**RE: ENVIRONMENTAL AUTHORITY AMENDMENT RESPONSE TO INFORMATION REQUEST
NOTICE – DUGALD RIVER MINE**

MMG submitted an amendment application for Environmental Authority (EA) EPML00731213, and Progressive Rehabilitation and Closure Plan, to the Department of Environment, Science and Innovation (DESI) on 8 August 2023 (REF:A-EA-AMD-100480009).

On 26 March 2024, the DESI determined that further information was required to assess the application and issued an Information Request Notice. Wulguru Technical Services acknowledges the Information Request Notice and has this letter in response. A revised Supporting Information Report and Progressive Rehabilitation and Closure Plan is also attached. We look forward to working with the DESI through the assessment process.

Appendix A – Response to Information Request

Figure 3: DRM Clean Water Diversions and Drainage Systems

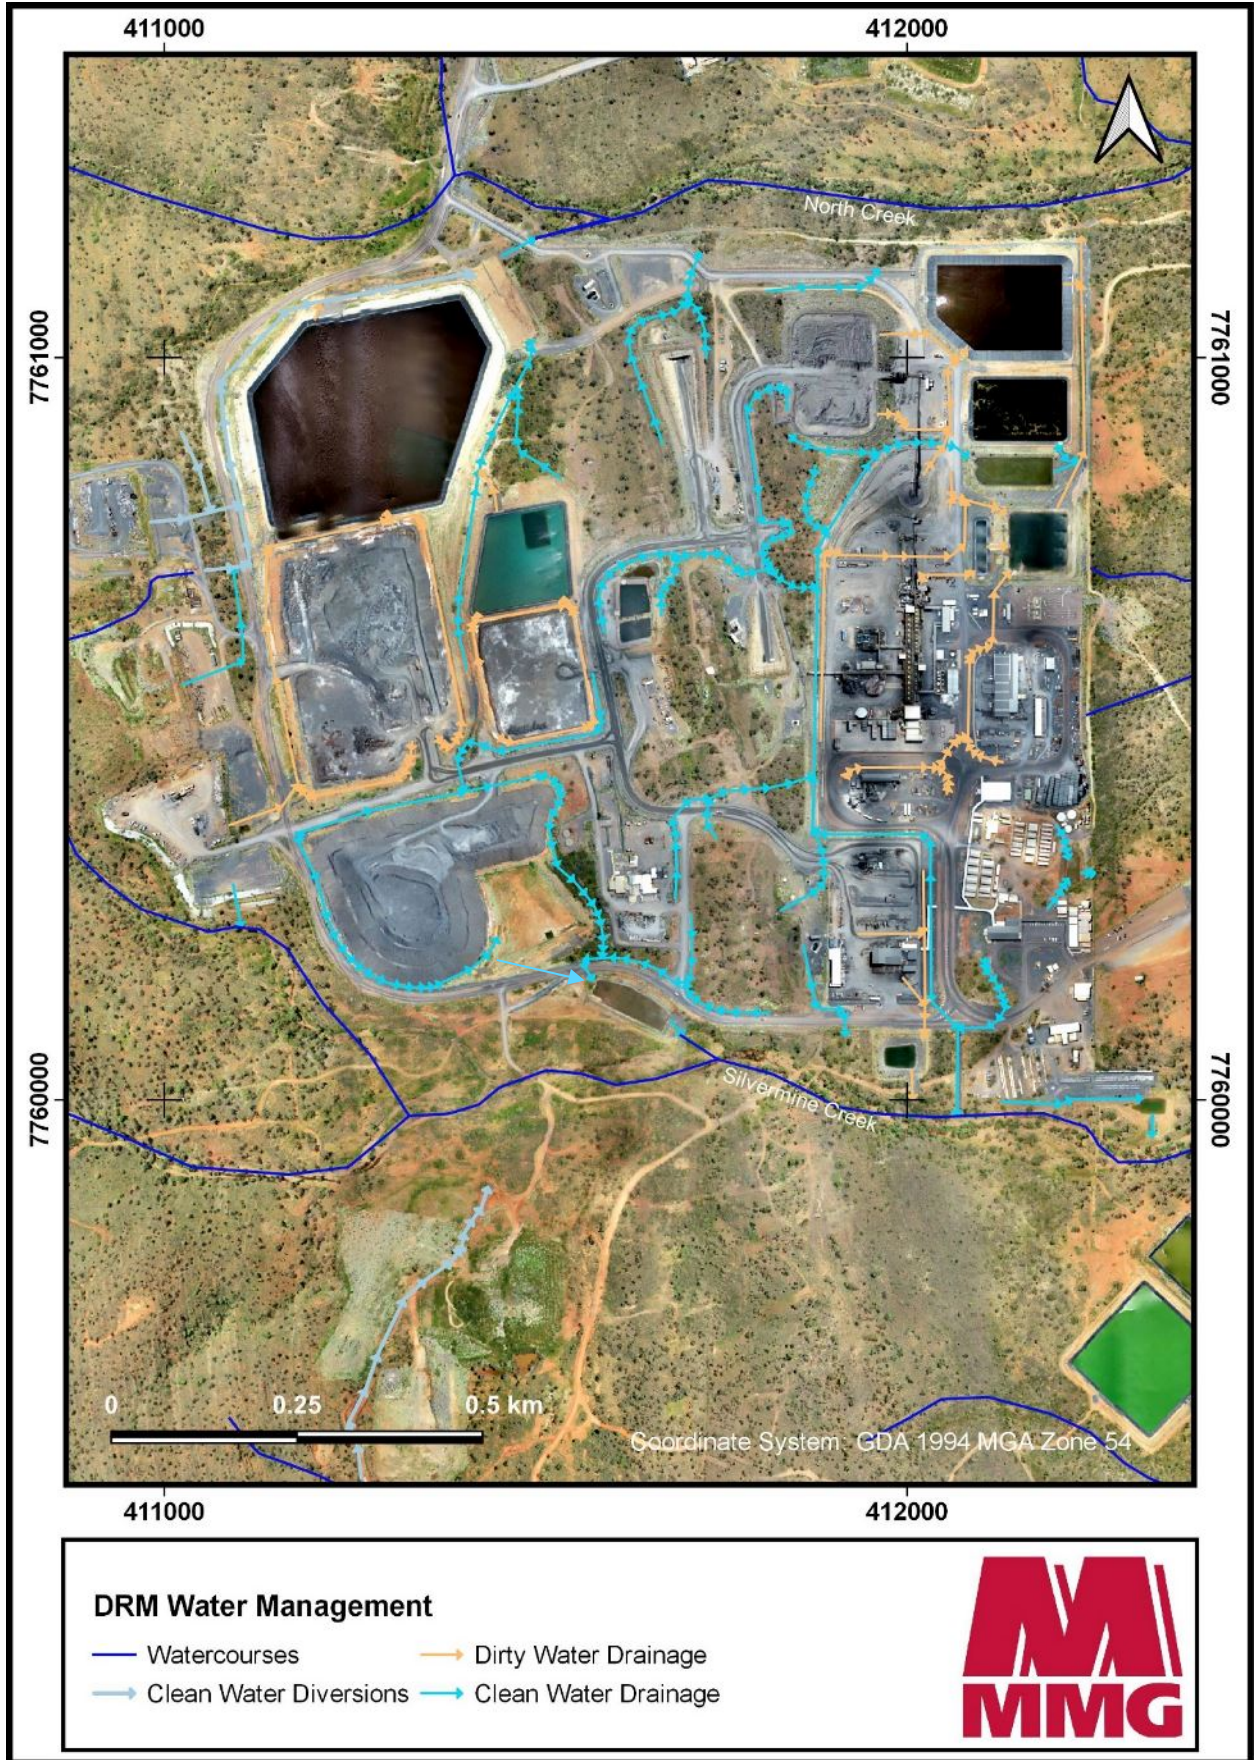
<p>Further, it is unclear if areas identified as 'electrical' in Figure 2 – Proposed Disturbance Areas have been accounted for in the total cumulative disturbance footprint proposed.</p> <p>Section 2.2.2. of the report discusses the proposed replacement of the sewage treatment plant (STP) which will require an additional 0.2 ha, however, Table 21 identifies this total area as 0.18 ha.</p> <p>Section 2.2.1.1.5 of the report states a switchyard is proposed on land previously disturbed. Further on, it is identified a second switchyard will be assembled to support electrical equipment (pg. 43). It is unclear the number of switchyards and the total disturbance area required for this feature as only one has been assessed, and Figure X – Proposed Windfarm only depicts 1.</p>			
2	<p><u>Wind turbines and laydown area</u></p> <p>In section 2.2.1. of the report, it is identified that the ninth location for the wind farm facility will be used as a laydown area for turbine components (eight wind turbines proposed). However, Figure X – Proposed Windfarm identifies nine turbine locations and an additional area named 'Windfarm Laydown' directly adjacent to the mine infrastructure area. It is unclear the total number of wind turbines</p>	<p>Clarify the total number of wind turbines supported by detailed mapping. Provide information outlining what 'turbine components' entails, and the potential land development required for this area (e.g., landform development/shaping, construction methodology, topsoil stripping and stockpiling and management measures).</p>	<p>There are eight turbines in total, WTG1 and WTG3 to WTG9. Figure 3 has been amended for clarity.</p> <p>Two temporary laydown areas (windfarm temporary laydown east, and windfarm temporary laydown west) have been designated to support construction activities, including for park bays</p>	<p>Section 2.2.1</p> <p>Figure 3</p>

<p>proposed, and the potential land development required for these areas.</p> <p>In addition, it is unclear what the material to be placed within the windfarm laydown area is suspected to be.</p>		<p>for light vehicles, elevated work platforms, etc.</p> <p>Large vegetation will be trimmed; vegetation groundcover and topsoil will remain undisturbed and no hardstands will be constructed.</p>	
3	<p><u>Matters of State Environmental Significance (MSES) - Regulated vegetation (essential habitat) and impacts to purple-necked rock wallaby (PNRW)</u></p> <p>Section 4.1.1.1.4. of the report outlines that the proposed renewables project will require clearing of approximately 68.7 ha of regulated vegetation - essential habitat, associated with the PNRW.</p> <p>A significant residual impact assessment (SRI) was undertaken (Table 39 of the report) which determined that impacts to this MSES value are likely to result in temporary disturbance to a subpopulation of PNRW associated with the clearance and construction phase of the project. However, within section 4.1.1.1.4. of the report, DRM have determined the proposed project is unlikely to significantly impact the population, with no proposed disturbance to any known PNRW colony and proposed tracks not transversing any known or suitable PNRW shelter habitat.</p>	<p>Provide clarification concerning impacts to the PNRW associated with the clearance of regulated vegetation (essential habitat) for this species.</p> <p>If there are impacts anticipated, undertake an assessment in accordance with the Queensland Environmental Offsets Policy to support the proposal and demonstrate that the offset hierarchy has been considered.</p>	<p>The total proposed disturbance to essential habitat has been clarified.</p> <p>A SRI has been undertaken and determined that the proposed amendment will not result in any significant residual impact to the essential habitat for the PNRW.</p> <p>An offset is not proposed for this matter.</p>	<p>Table 20</p> <p>Section 4.1.11</p> <p>Appendix K</p>
